DART SERVICE INSTRUCTION

TO AMEND IIN-D412-704 REV. C OR EARLIER
AND ICA-D412-704 REV. 4 OR EARLIER
REF CANADIAN STC SH93-34
REF FAA STC SR00957NY
REF EASA STC EASA.IM.R.00696

PURPOSE

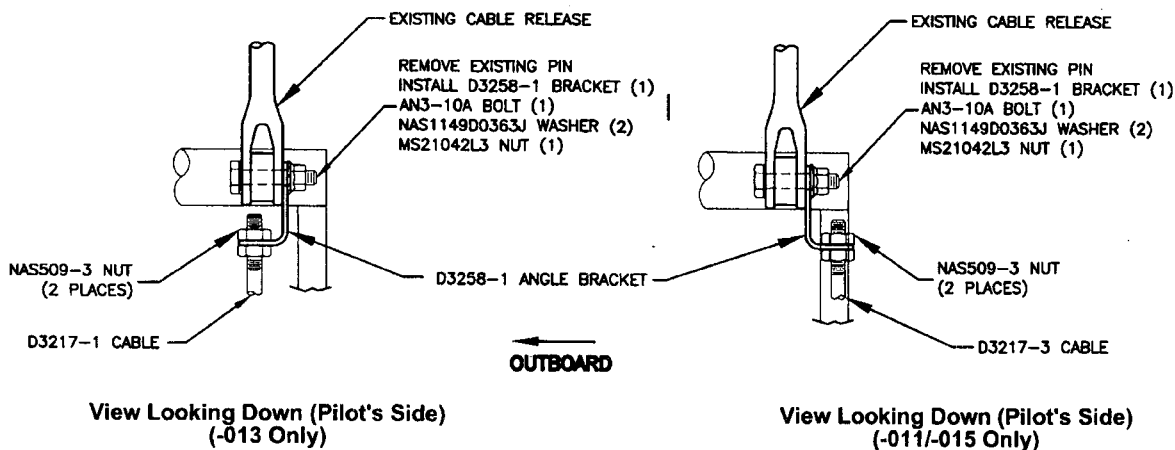
PART LIST CORRECTION

Revise Part Lists in IIN-D412-704 & ICA-D412-704 as follows:

Qty -043	Qty -045	Part Number	Description
X		D205-704-043	CABLE ASSEMBLY (205)
	X	D412-704-045	CABLE ASSEMBLY (210/212/214/412)
1	1	AN3-10A	BOLT

Figure 5 - Detail L or Figure 25-4 - Detail L

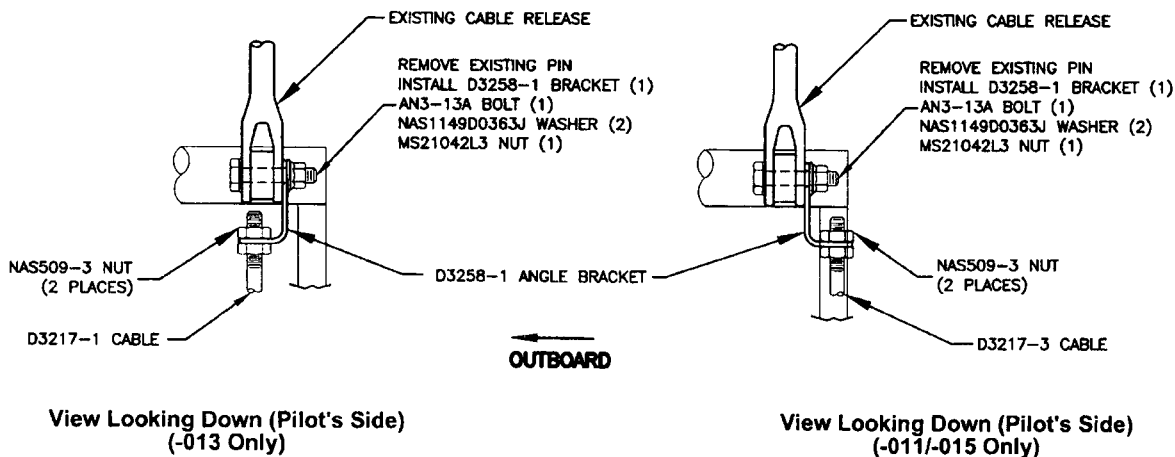
The purpose of this Dart Service Instruction is to correct part number error in Installations Instruction IIN-D412-704 Rev. C or earlier and Instructions for Continued Airworthiness ICA-D412-704 Rev. 4 or earlier. The AN3-13A bolt should be replaced with an AN3-10A bolt in Figure 5 - Detail L in IIN-D412-704 and Figure 25-4 Detail L in ICA-D412-704. See sheet 2.

FIGURES CORRECTION

Revise Detail L Figure 5 of IIN-D412-704 and Detail L Figure 25-4 of ICA-D412-704 as follows:
